de HAVILLAND

53-7-1 de Havilland Applies to Model DHC-2 (Beaver) Aircraft, Serial Numbers 1 to 483 Inclusive.

53-9-2 de Havilland Applies to All Model DHC-2 Beaver Aircraft.

53-10-2 de Havilland Applies to Model DHC-2 (Beaver) Aircraft, Serial Numbers 1 to 401 Inclusive.

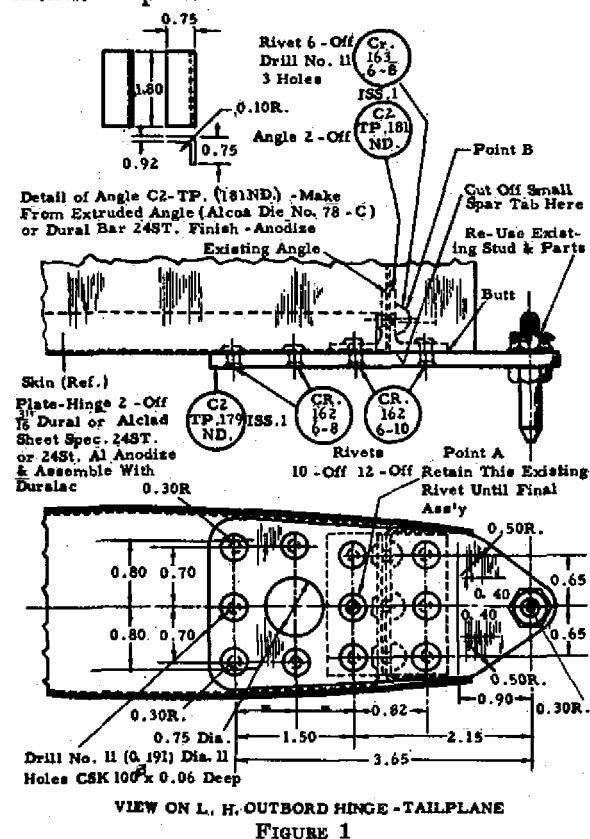
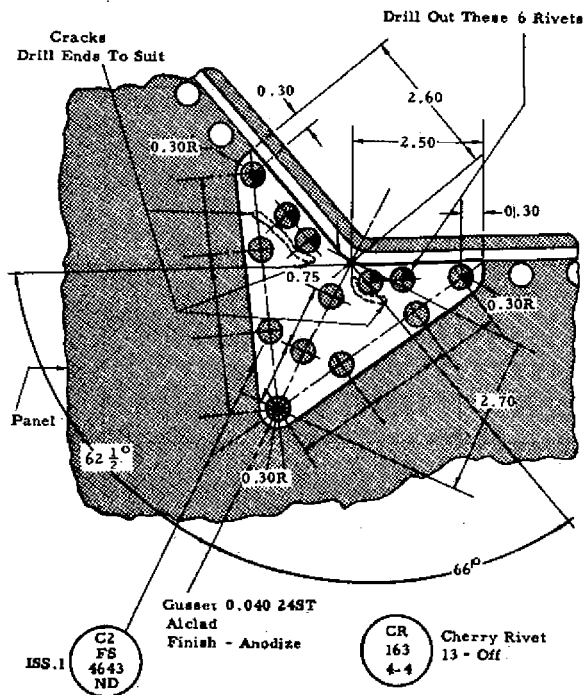
There have been instances of the elevator outboard hinge becoming loose in its attachments to the horizontal stabilizer rib. Rivet holes have become enlarged permitting the fitting to "work". The de Havilland Aircraft of Canada, Ltd., in agreement with the Canadian Department of Transport, issued the following mandatory instructions in which the FAA concurs:

Repair scheme: The repair scheme described herein is not mandatory until a defect appears. (See Fig. 1.)

Important: Do not drill out rivet at point A until angle C2-TP-181ND has been riveted. (See Fig. 1.)

6. Drill out 3 rivets at point B securing angle C2-TP-139. (Angle must still remain in position secured by 1 rivet at point A.)

7. Locate new angle C2-TP-181ND on spar rear face and flush with outer skin of end rib.
8. Rivet angles C2-TP-139 and -181ND to spar as shown at point B.
9. Drill out rivet at point A.

10. Make or secure new hinge plate C2-TP-179ND and assemble as shown.

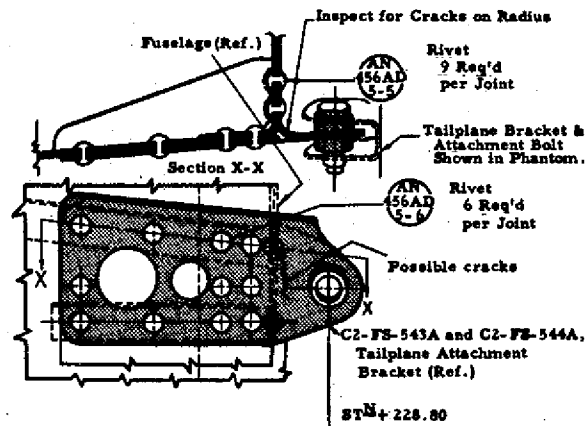
When filling the fuel tanks, it is possible for spilled fuel to seep down between the fuel tank filler neck recess box and the aircraft's outer skin. This permits gasoline fumes to accumulate in the tank bays beneath the floor and can create a fire hazard. The aircraft should be inspected to ascertain if a satisfactory seal exists between the filler neck recess box (C2-FS-1005ND) and the outer skin (C2-FS-3829ND). If seal is unsatisfactory, fill gap with either "Goodyear Plyabond" or "Minneapolis Mining EC776" metal sealing compounds or equivalent. In the interim, until resealing is accomplished, a "No Smoking" placard should be installed in the cabin. The FAA concurs in this mandatory action by the Canadian Department of Transport.

FIGURE 1

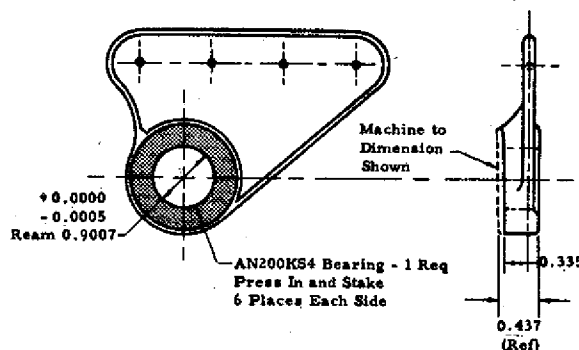
To reduce the possibility of failure of the wing bulkhead assemblies and subsequent loss of the ailerons:

1. Machine face of boss on fitting assemblies P/N 4154028 and 4154028-1, to 0.335 inch, and ream bore to 0.9007 ± 0.0000 , -0.0005 inch. (See Figure 1.) Replace bearing AN 209K4A with self-aligning bearing, P/N AN 200KS4 and stake in six places each side. Install reworked fitting assemblies, P/N 4154028 and 4154028-1, on original bulkheads as follows:

(a) On installations using two screws, P/N 1029421-416-11, or two bolts, P/N AN 4-6A, and three rivets, enlarge the rivet holes in the fitting and bulkhead to 0.191-inch diameter and countersink the holes in bulkhead 100° . Install fitting using two screws, P/N 1029421-416-11 or NAS 214-11, or two bolts, P/N AN 4-6A, originally installed, two washers, P/N AN 960D416, and two nuts, AN 365-428, in the top and bottom holes, and three screws, P/N S-1029421-10-12, three washers, P/N AN 960D10, and three nuts, P/N AN 365-1032, in the three remaining holes.

FIGURE 1

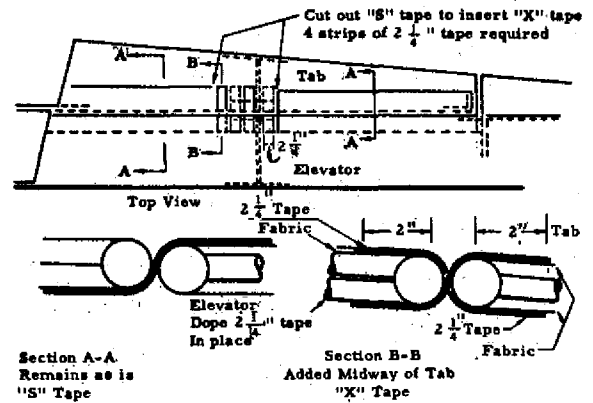
As the result of a recent failure of the elevator trim tab in flight, the modification of the trim tab attachment to the elevator as shown in Figure 1 should be made.
